ARTHUR J. MARCUS ARCHITECT P.A.

re: 1235 Lenox Avenue  
Miami Beach, Florida 33139

EXISTING RESIDENCE

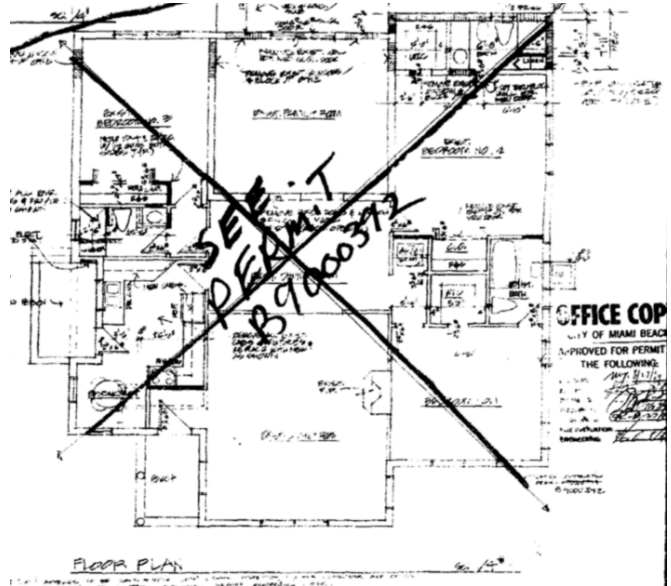
The only floor plan available for the house is a 1990 architectural permit plan of the residence prior to additions as shown above. Even though crossed out the plan of the house is quite legible - prior to the additions..

The original residence contained a certain rustic charm with the red tile pattern framing the arched opening, However the insertion of rectangular windows inside this rather elegant arched opening is more likely what I have labeled as the Contractor Moderne Style.

The 2.11.20 Staff Report on this property states that the alterations to the front façade were completed during this 1990 renovation as shown in left below photo, and I agree with this premise.

Modifications to the front façade in 1990 appear to include the introduction of rough-hewn stone cladding and the removal of the chimney structure along with retaining the unfortunate insertion of windows inside the arched opening. And this opening apparently mimics the original windows shown in left above photo.
